# Revised baseline scenario and quantitative climate impact assessment in respect of Drax Re-power (App. No. EN010091)

9 January 2019

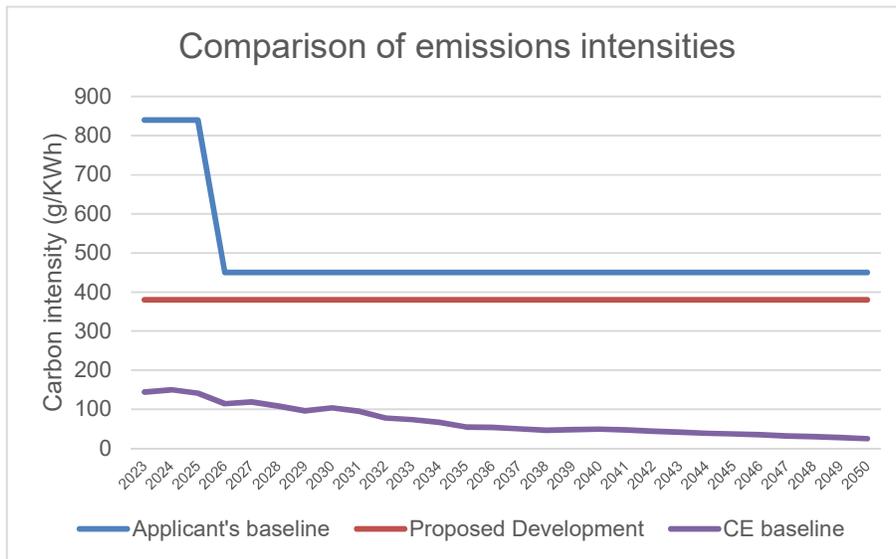
14. As the revised tables indicate, applying ClientEarth’s revised baseline results in the Proposed Development having a total net emissions effect of +238.7 MtCO<sub>2</sub>e / +488% and an emissions intensity +443% higher than the baseline. This compares to a total net emissions effect of +168.6 MtCO<sub>2</sub>e / +90% and an emissions intensity effect of between -16% and -55% in the Applicant’s assessment. The Applicant’s Tables 15-13 and 15-15 are included at Annex B for reference.

15. The below graphic illustrates the difference between the Proposed Development's emissions intensity, the Applicant's baseline emissions intensity and the Government projections for average emissions intensity used in the ClientEarth (CE) baseline.
